We have received the attached Federal Emergency Management Agency (FEMA) letter dated April 25, 1985, and associated evaluation of the Alert and Notification System for the Monticello Nuclear Generating Plant in Monticello, Minnesota.

The Federal Emergency Management Agency (FEMA) has completed an analysis of the prompt alert and notification system for the Monticello Nuclear Generating Plant in Monticello, Minnesota. This review has been completed pursuant to FEMA rule 44 CFR 350; selected evaluative criteria and Appendix 3 in NUREG-0654/FEMA-REP-1, Rev. 1; and FEMA-43, the "Standard Guide for the Evaluation of Alert and Notification Systems for Nuclear Power Plants." The enclosed report entitled "Monticello Nuclear Generating Plant Site-Specific Offsite Radiological Emergency Preparedness Alert and Notification System Quality Assurance Verification," summarizes the engineering design review, incorporates the results of the telephone survey of the public conducted immediately following the alert and notification system activation on October 3, 1984, and includes the results of the review of the other applicable evaluative criteria from NUREG-0654/FEMA-REP-1, Rev.1, and FEMA-43.

FIGURE 8

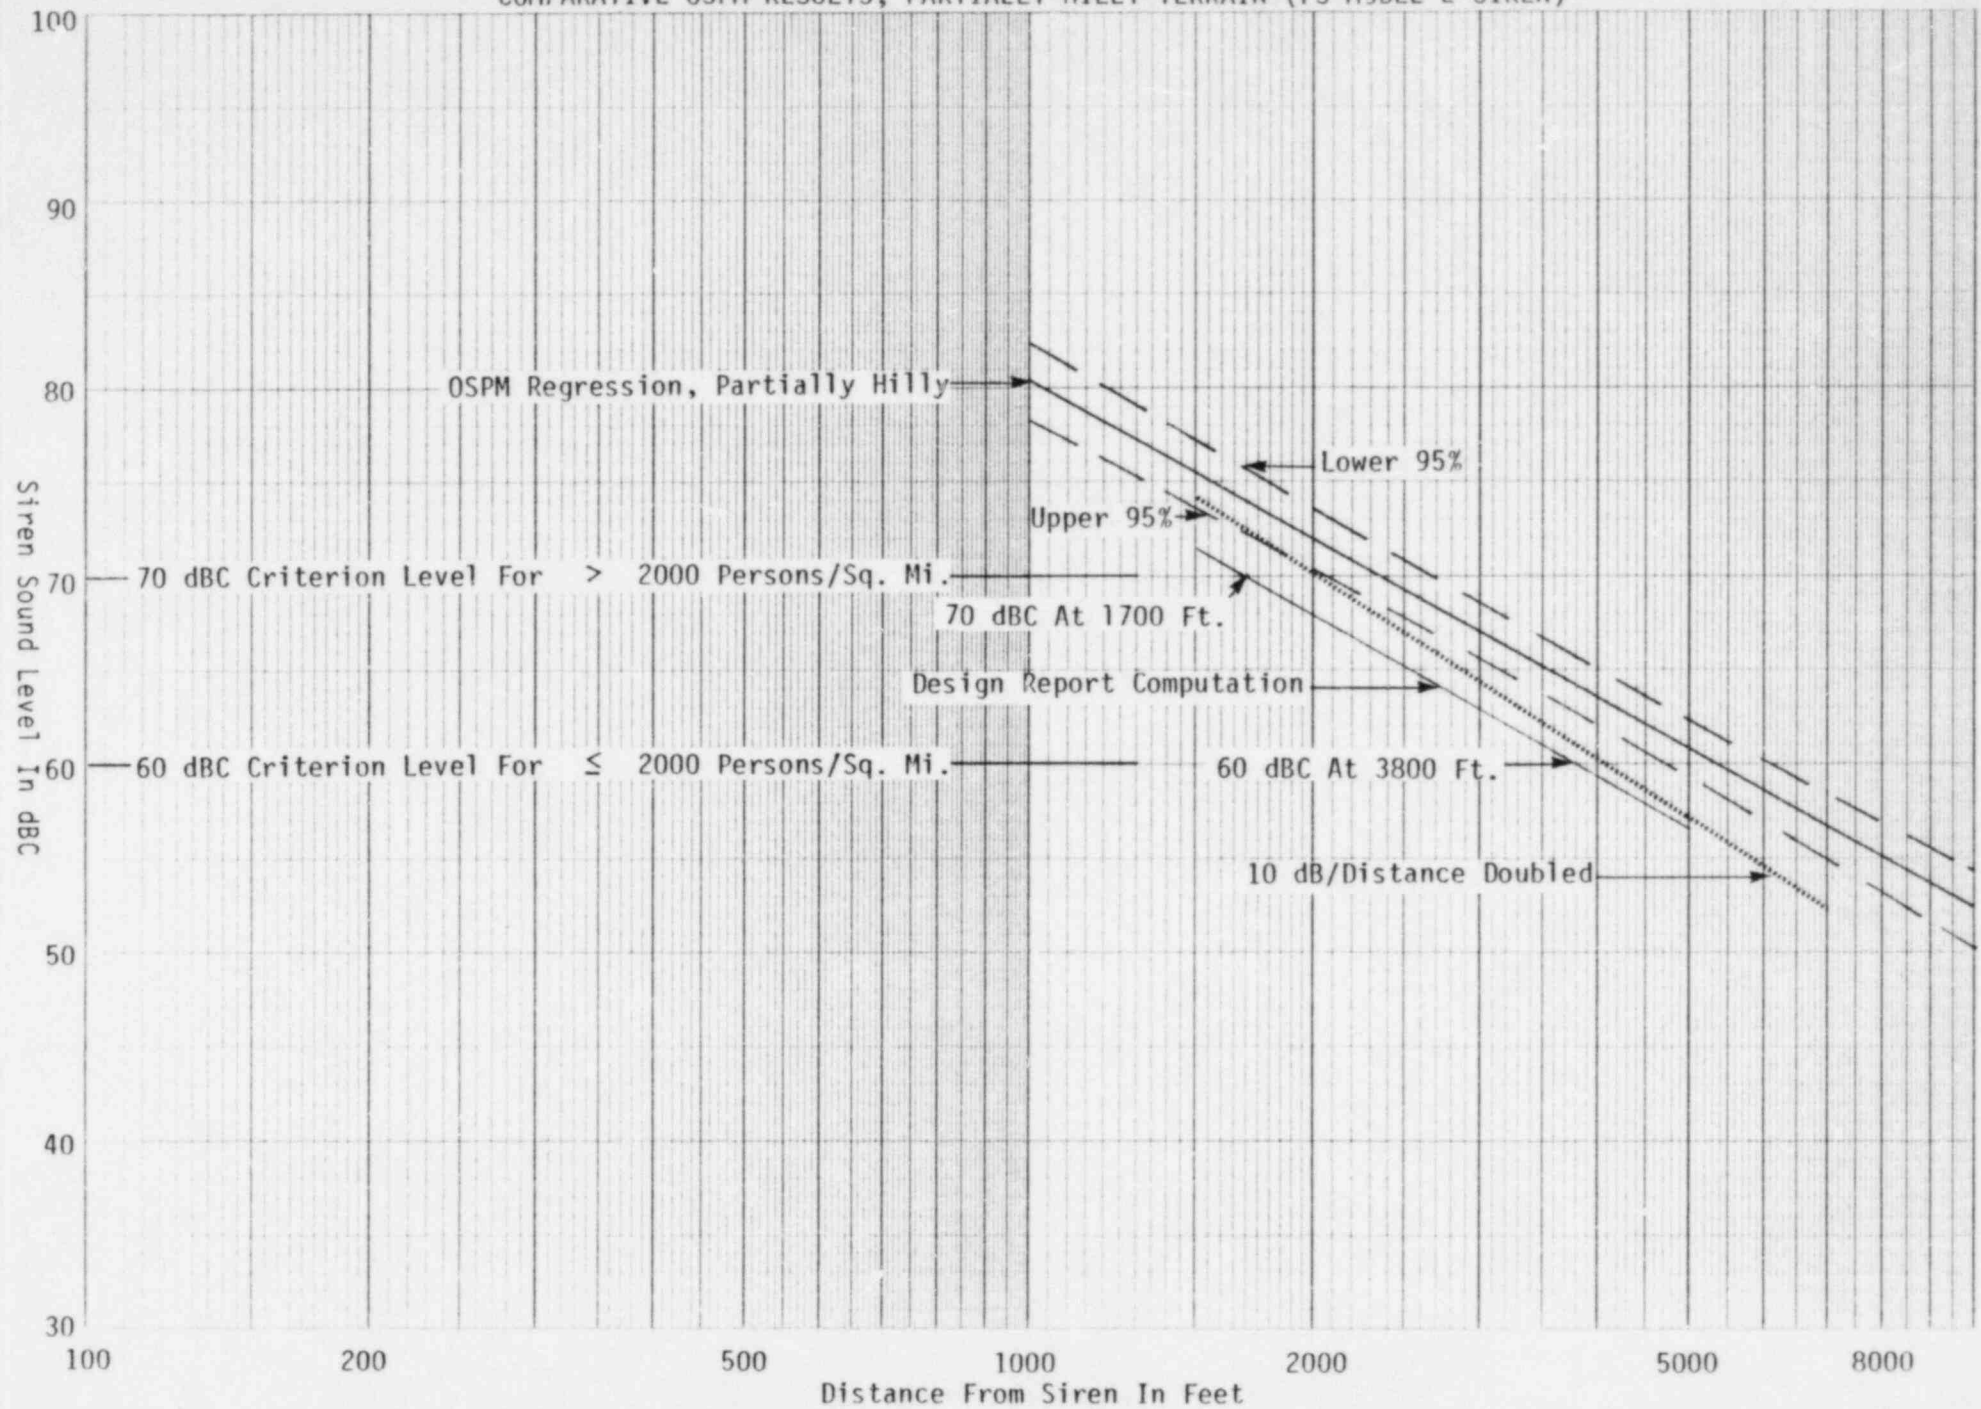
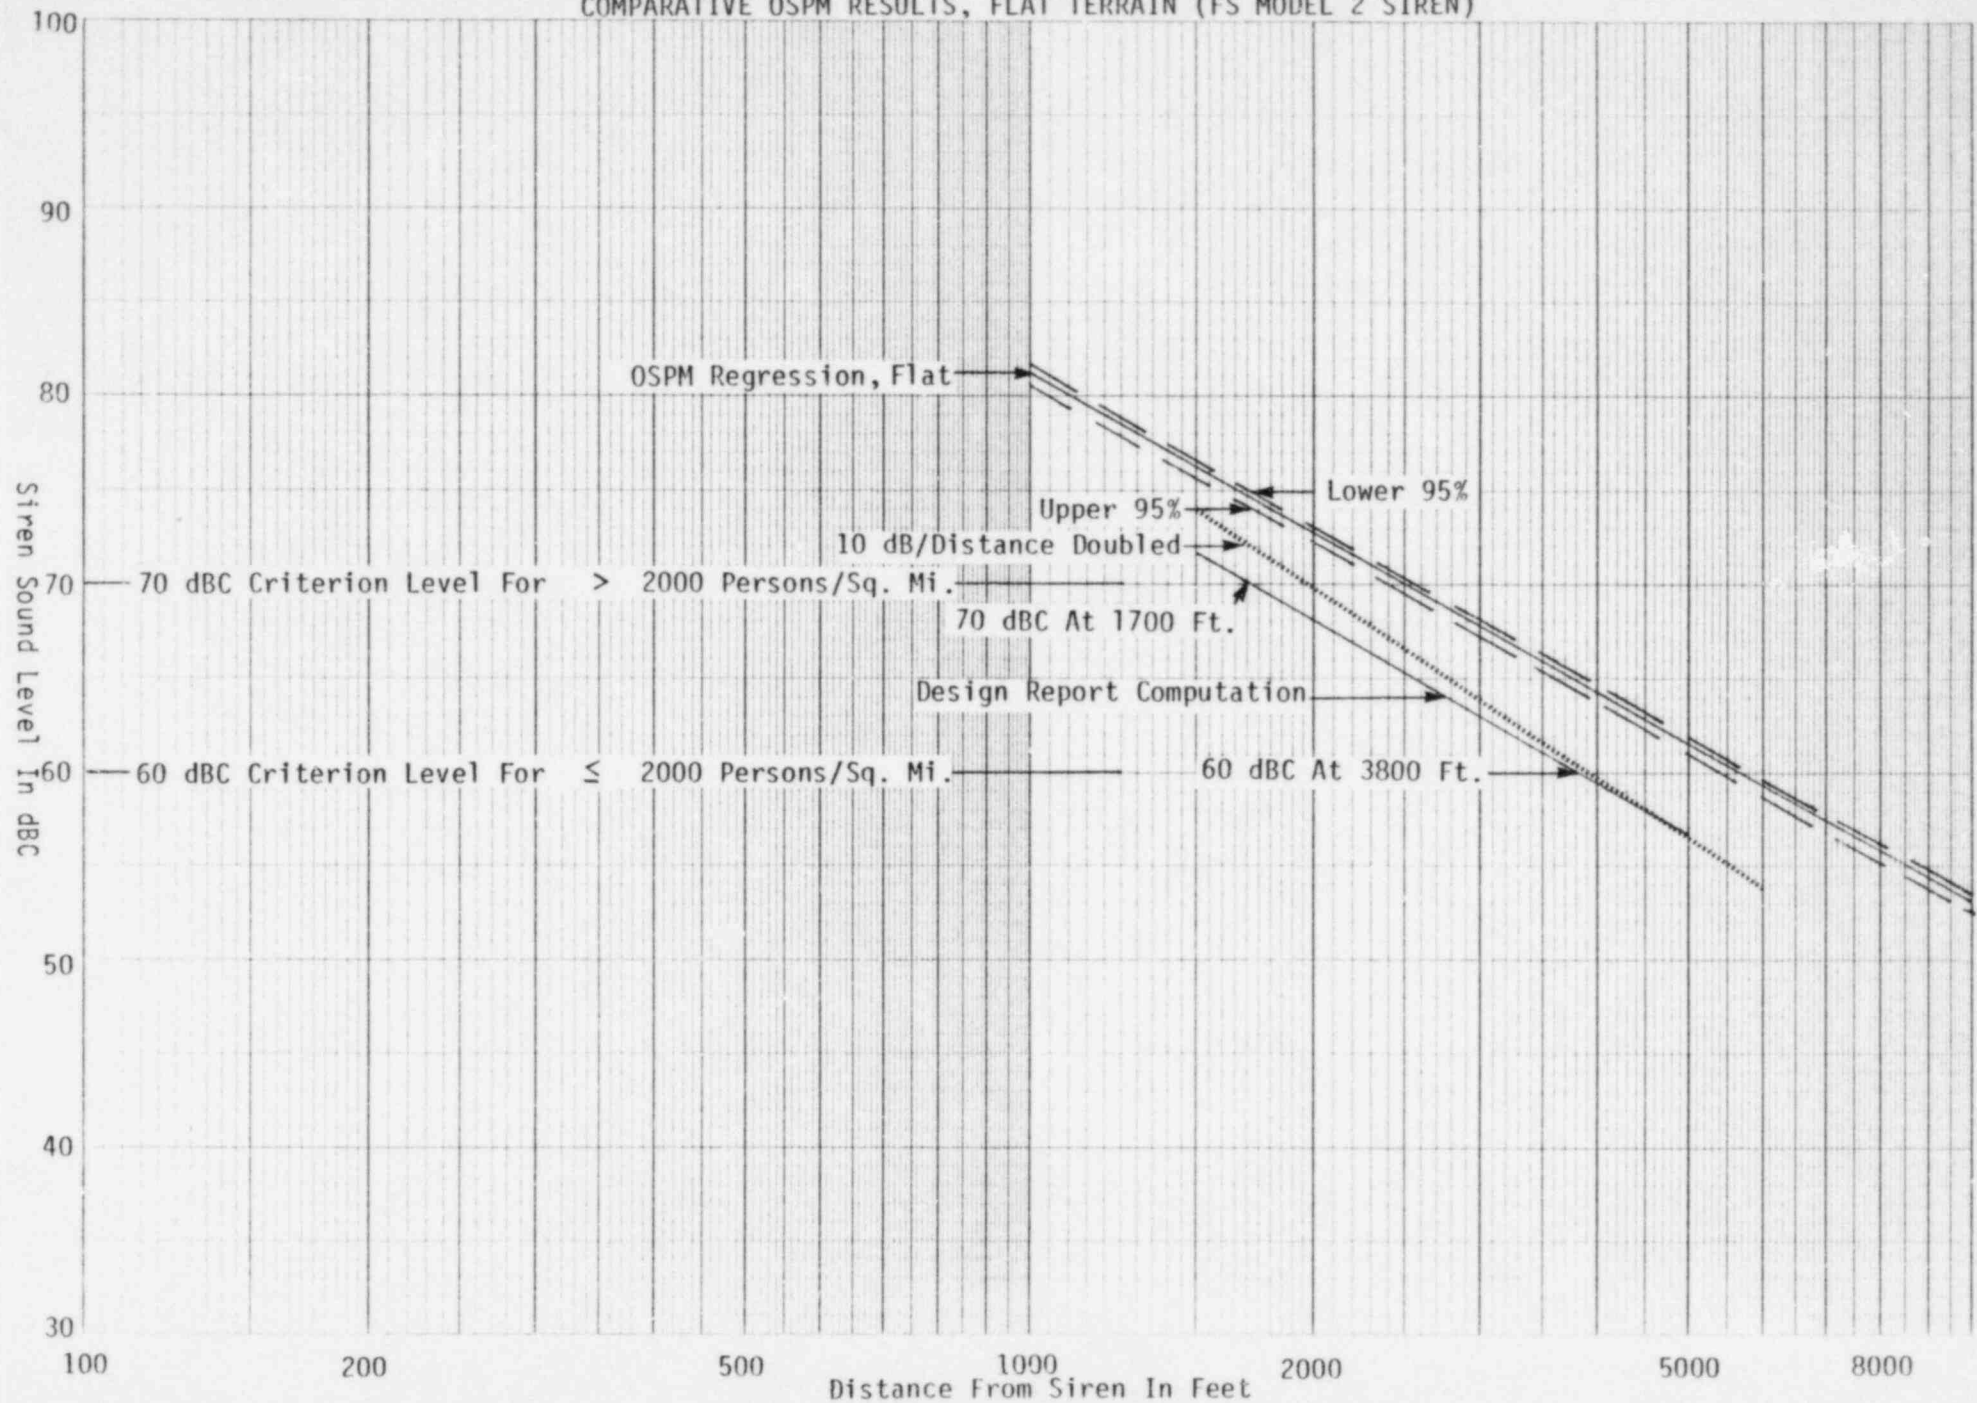
The results of the individual OSPM runs were combined to generate a comprehensive overview of the siren sound pressure levels over both the Monticello and Buffalo areas as depicted in Figures 2 and 3. A surface interpolation and contouring program utilizing the output results of the 14 sirens was used to generate the sound pressure level contour overlays. These contours account for site-specific topographical and meteorological effects. Comparisons of the OSPM predicted 70 dBC and 60 dBC

contours with the contours in the Wyle Report (Map 1) indicate that the siren coverage as calculated in the Wyle Report is very conservative in the Buffalo and Monticello areas and similar to OSPM results in hilly terrains.\*

The design procedure results in a reasonably conservative overall estimate of Monticello Nuclear Generating Plant's siren warning system coverage and is found to be adequate in satisfying FEMA-43 specific design requirements.
